DOMESTIC BUILDING ASSESSMENT REPORT

DBDRV-2017-6-1436

29 Stones Rd DEREEL VIC 3352

Gap under doors

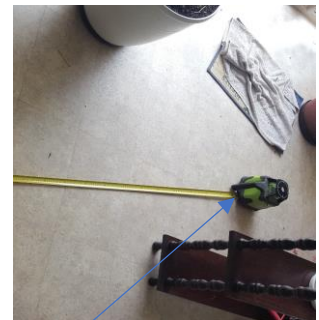
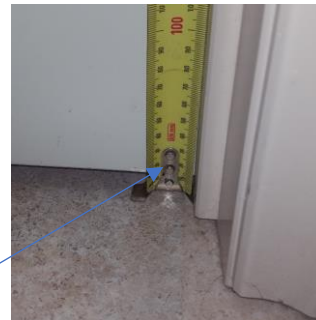
Item four: *The floor is uneven, with differences of up to 5 mm. The gap under the door of the main bedroom is several millimetres higher on the right than on the left.*

Approx. 4 mm difference across doors measured

Laser level Dining floor

1. A visual assessment was carried out of the floor levels to bedroom door, Dining & Living floors.
2. The assessment revealed that when an automatic levelling laser level was applied to the Dining Living floor and the levels were within 4 mm of each other in any 2000 mm direction. Within the whole area there was a difference of up to 5 mm.
3. Under doors a difference was noted of up to 4 mm side to side.
4. In accordance with the *Guide*, floors must not differ by more than 10 mm in any room or area. Therefore the item is not defective.

No, it is not defective.
